SUBJECT: COMANCHE PEAK STEAM ELECTRIC STATION, UNITS 1 AND 2 -
ISSUANCE OF AMENDMENTS RE: INCREASE IN ALLOWABLE SPENT FUEL
STORAGE CAPACITY AND CREDIT FOR SOLUBLE BORON IN THE SPENT
FUEL POOL (TAC NOS. MA4841 AND MA4842)

SAFETY EVALUATION BY THE OFFICE OF NUCLEAR REACTOR REGULATION

COMANCHE PEAK STEAM ELECTRIC STATION, UNITS 1 AND 2

DOCKET NOS. 50-445 AND 50-446

FIGURE 3.7.17-1
Fuel Assembly Burnup vs. U-235 Enrichments vs. Decay Time Limits for
All Cell Storage in High Density Spent Fuel Storage Racks

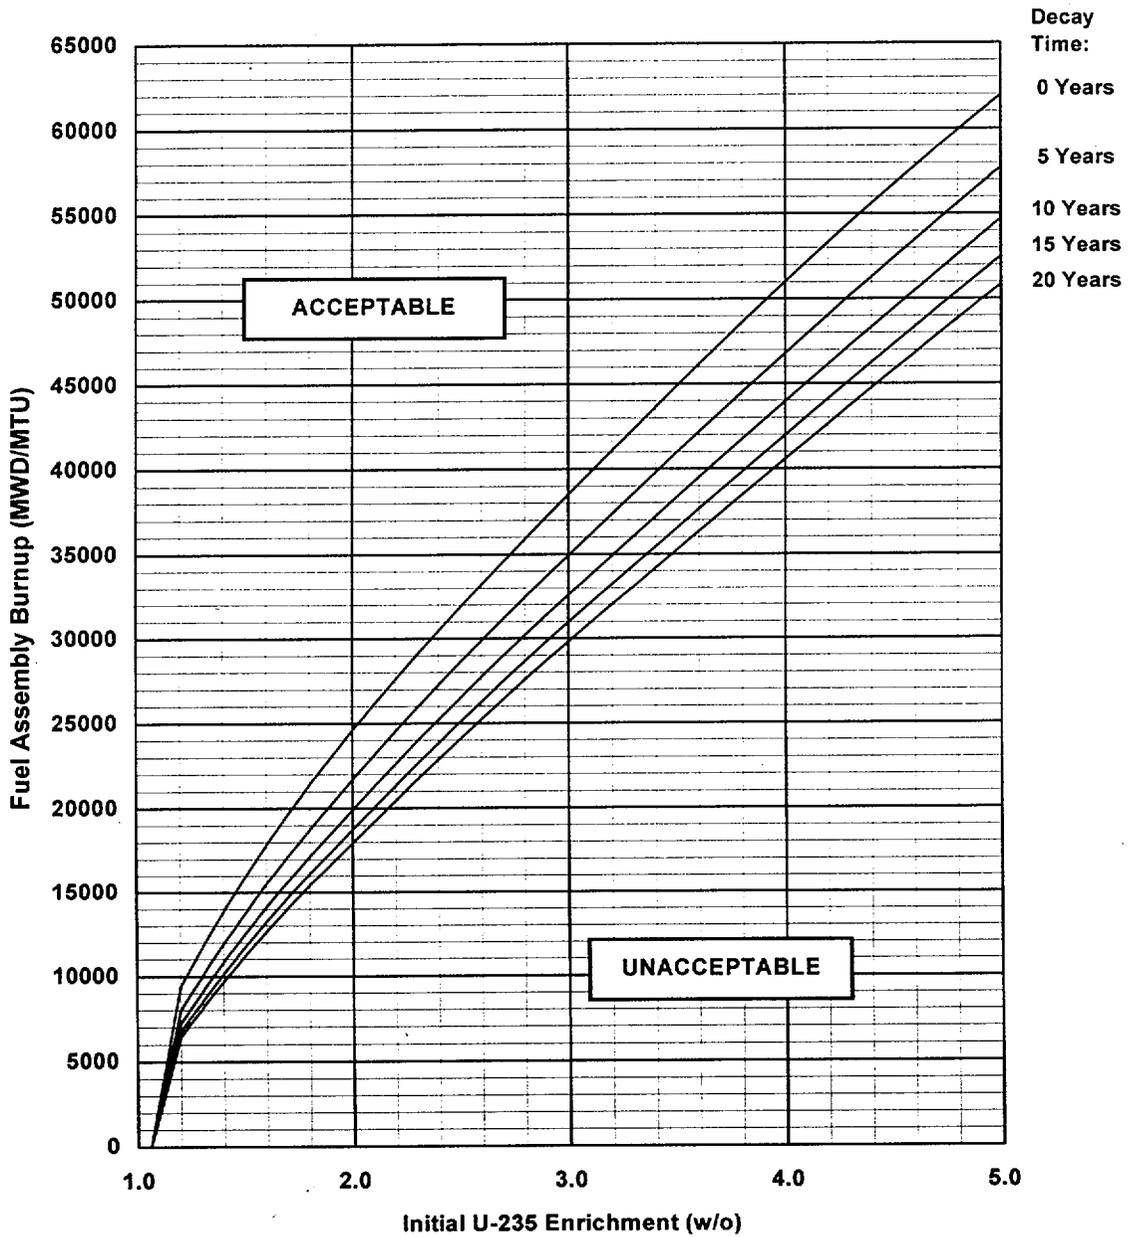
The concept of reactivity equivalencing due to fuel burnup was used to achieve the storage of fuel assemblies with enrichments higher than 1.05 w/o U-235 for the all cell storage configuration, and > 1.54 w/o U-235 for the 3 out of 4 checkerboard configuration. The NRC staff has previously accepted the use of reactivity equivalencing predicated upon the reactivity decrease associated with fuel depletion. To determine the amount of soluble boron required to maintain $k_{\text{eff}} \leq 0.95$ for storage of fuel assemblies with maximum enrichments up to 5.0 w/o U-235 for both the all cell configuration and the 3 out of 4 configuration, a series of reactivity calculations were performed to generate a set of enrichment versus fuel assembly discharge burnup ordered pairs which all yield an equivalent k_{eff} when stored in the CPSES spent fuel storage racks. These are shown in the licensee's proposed TS Figures 3.7.17-1 and 3.7.17-2 for the all cell configuration and the 3 out of 4 configuration, respectively. These curves

represent combinations of fuel enrichment and discharge burnup which yield the same rack k_{eff} as the rack loaded with fresh (zero burnup) fuel with the maximum allowed enrichments derived previously. Uncertainties associated with burnup credit include a reactivity uncertainty of 0.01 Δk at 30,000 Mega-watt Days per Metric-ton of Uranium (MWD/MTU) applied linearly to the burnup credit requirement to account for calculational and depletion uncertainties and 5% on the calculated burnup to account for burnup measurement uncertainty. The NRC staff concludes that these uncertainties conservatively reflect the uncertainties associated with burnup calculations and are acceptable. The amount of additional soluble boron, above the 200 ppm value required above, that is needed to account for these uncertainties is 550 ppm for the all cells configuration and 450 ppm for the 3 out of 4 configuration. This results in a total soluble boron credit of 750 ppm for the all cell configuration and 650 ppm for the 3 out of 4 checkerboard configuration. These values are well below the minimum SFP boron concentration value of 2,000 ppm required by proposed TS 3.7.16 and are, therefore, acceptable.

Proposed TS Figures 3.7.17-1 and 3.7.17-2 also credit the time an assembly has been discharged from the core. Decay time credit is an extension of the burnup credit process and results from the radioactive decay of isotopes in the spent fuel to daughter isotopes, which results in reduced reactivity. Although decay of the fission products has the effect of further reducing the reactivity of the spent fuel, in this amendment request, credit is taken only for the decay of actinides. Decay time credit has been previously approved by the NRC staff (Reference 9).

Assemblies with initial nominal enrichments no greater than 1.06 w/o U-235 can be stored in any cell location. Fuel assemblies with initial nominal enrichments greater than 1.06 and up to 5.00 w/o U-235 must satisfy the minimum burnup requirements shown in proposed TS Figure 3.7.17-1.

Figure 3.7.17-2
Minimum Burnup vs. Initial U-235 Enrichment vs. Decay Time
For a 3 out of 4 Storage Configuration in High Density Racks

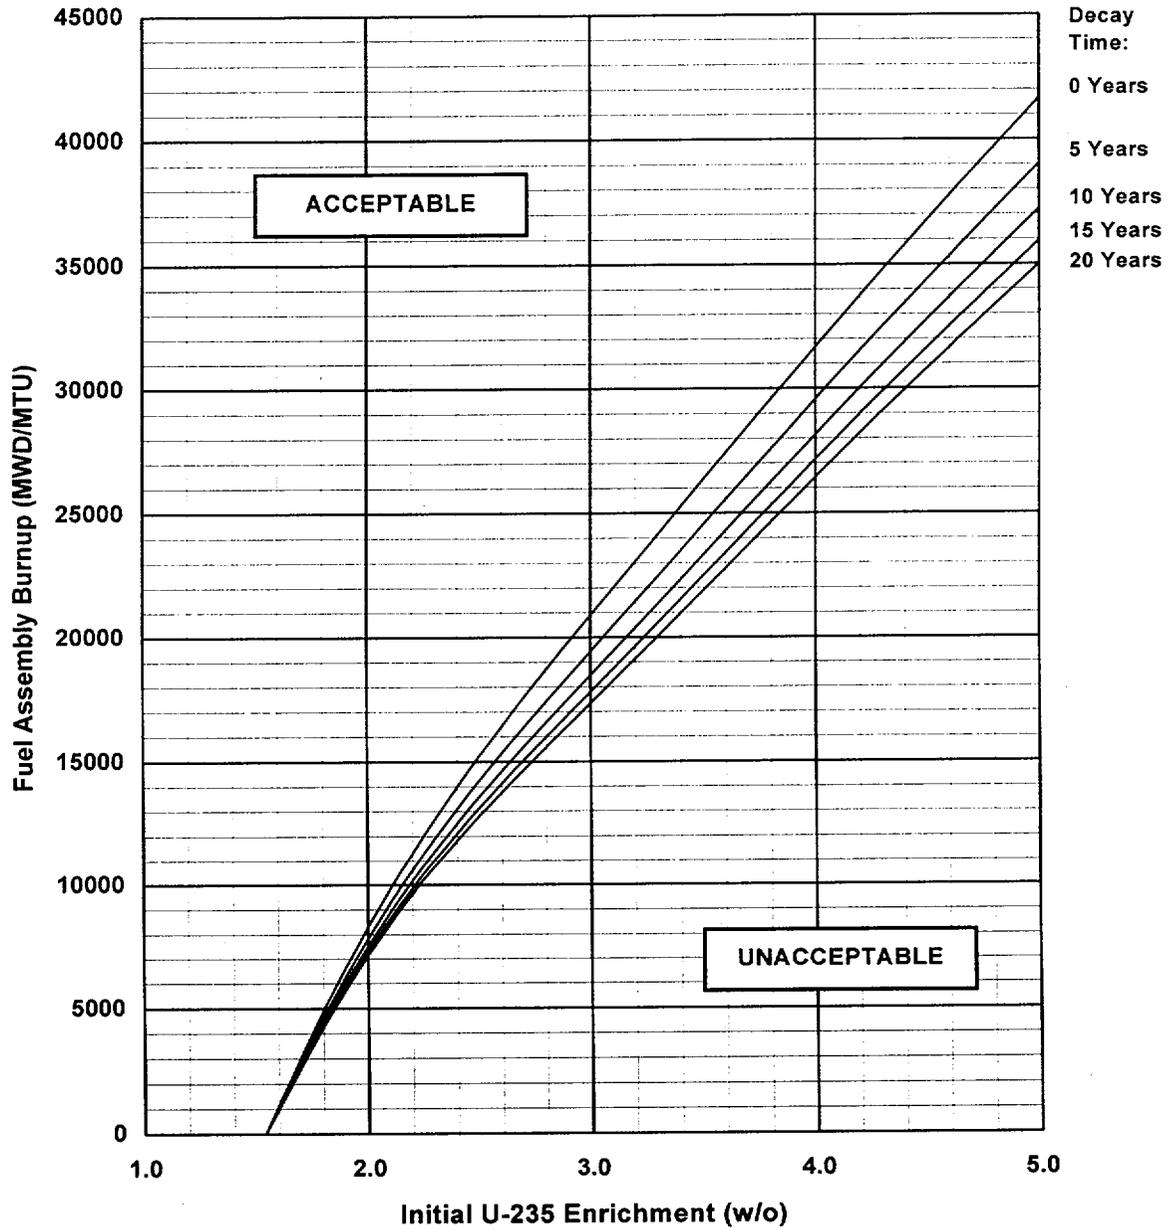
Assemblies with initial nominal enrichments no greater than 1.54 w/o U-235 can be stored in a 3-out-of-4 storage configuration arrangement with empty cells. Fuel assemblies with initial nominal enrichments greater than 1.54 and up to 5.00 w/o U-235 must satisfy the minimum burnup requirements shown in proposed TS Figure 3.7.17-2.

Figure 3.7.17-3
Minimum Burnup vs. Initial U-235 Enrichment
For a 2 out of 4 Storage Configuration in High Density Racks

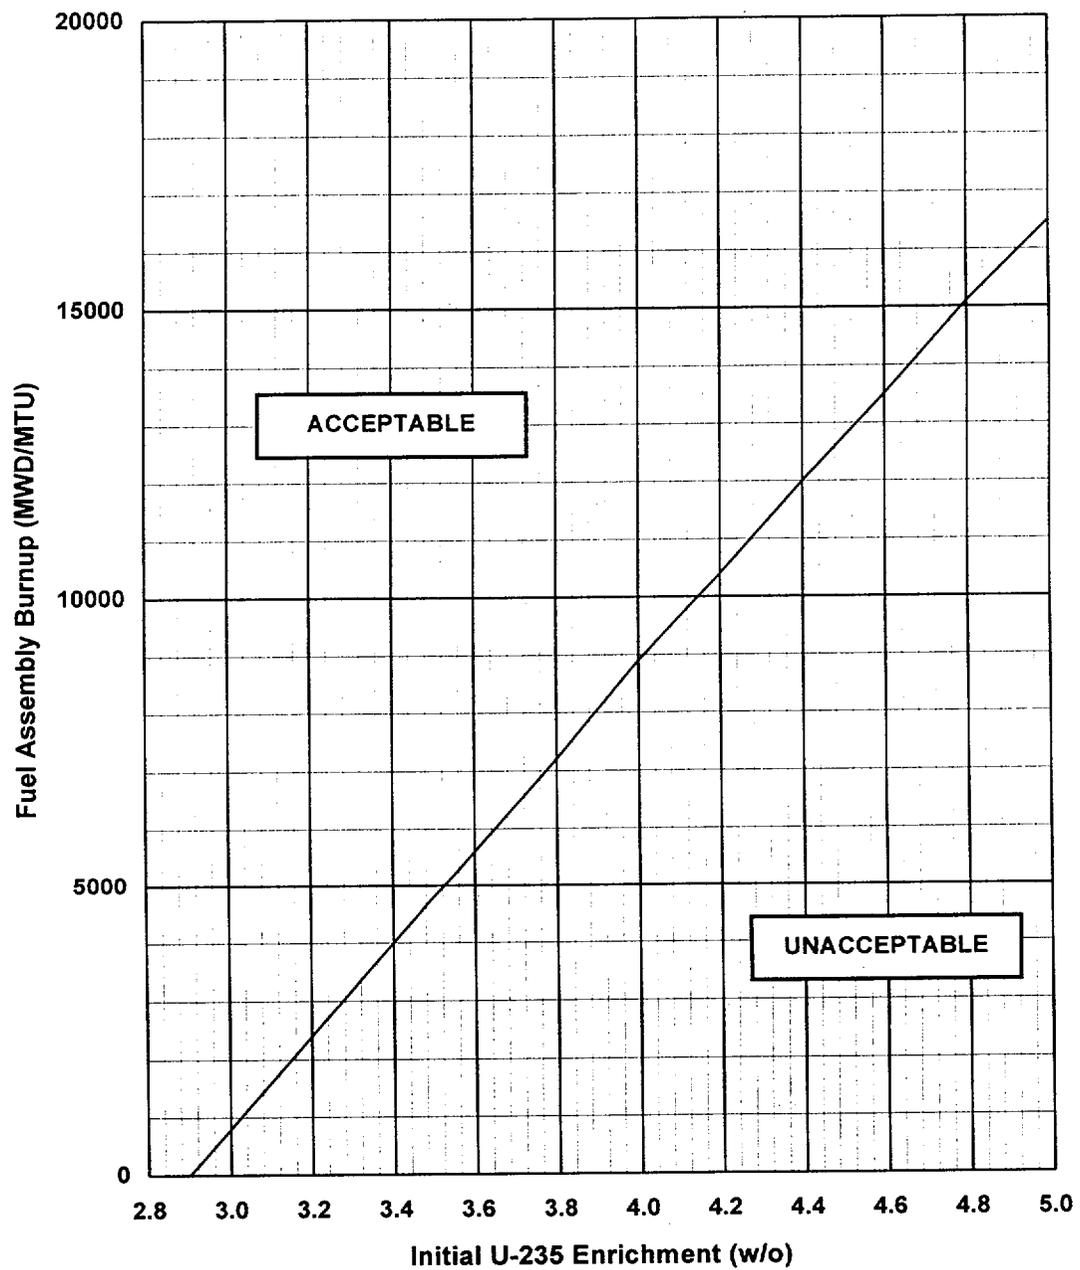
- The licensee has proposed a revision to CPSES TS 3/4.7.17, "Spent Fuel Assembly Storage." The proposed changes would incorporate limitations for "All Cell Storage" and "3 out of 4 Storage" configurations in TS Figures 3.7.17-1 and 3.7.17-2, respectively. These TS figures are acceptable as described in Section 3.5, herein. A revised TS Figure 3.7.17-1, for the "2 out of 4 Storage Configuration" would become TS Figure 3.7.17-3. The existing TS Figure 3.7.17-1 was found to contain a minor error which resulted in an overly restrictive requirement for storing fuel in a "2 out of 4 Storage Configuration." The NRC staff concludes that the revised TS Figure 3.7.17-1, which becomes TS Figure 3.7.17-3, is acceptable. A new TS Figure 3.7.17-4 would be added to provide a pictorial definition of the various acceptable fuel storage configurations. These pictorial definitions are consistent with the NRC staff's understanding of the definitions of the various acceptable storage arrays. Accordingly, proposed TS Figure 3.7.17-4 is acceptable.
